March 1, 2019

FROM: Andrea M. Campisi, Senior Planner, Building and Planning Department

SUBJECT: PRELIMINARY LAND DEVELOPMENT PLAN, 637 W. Montgomery Avenue, (aka 625 Montgomery Avenue), Bryn Mawr Presbyterian Church, Bryn Mawr, LD# 3826, Ward 10.

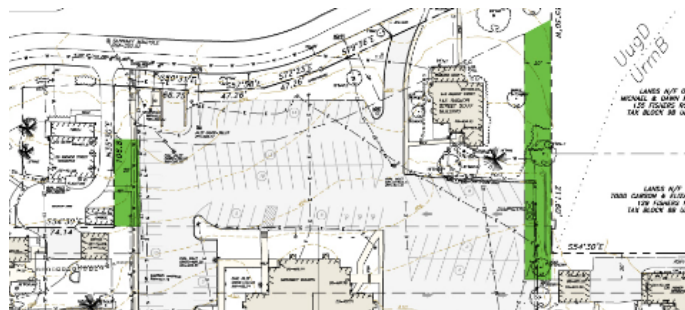
Since the property is in close proximity to commercial and other institutional uses and is within a Priority Three area on the Prioritized Pedestrian Improvement Map in the Comprehensive Plan, staff recommends that the applicant install sidewalks along those portions of Radnor Street where they do not already exist.

Sidewalks exist along the entire frontage of the property along Montgomery Avenue and Fishers Road. In addition, a portion of the frontage along Radnor Street contains a blacktop walkway that terminates in a step down to the driveway serving the residence at 127 Radnor Street. If sidewalks are added to the rest of Radnor Street, staff recommends the step be removed and the area regraded to provide a smooth transition. In addition, the existing sidewalk extending out to Radnor Street from the rear parking lot of the church (shown in the graphic) should be extended to meet the public sidewalk. If sidewalks are not installed then relief from Subdivision and Land Development Code Section 135-28 is required. Currently the applicant has not submitted a request for relief.
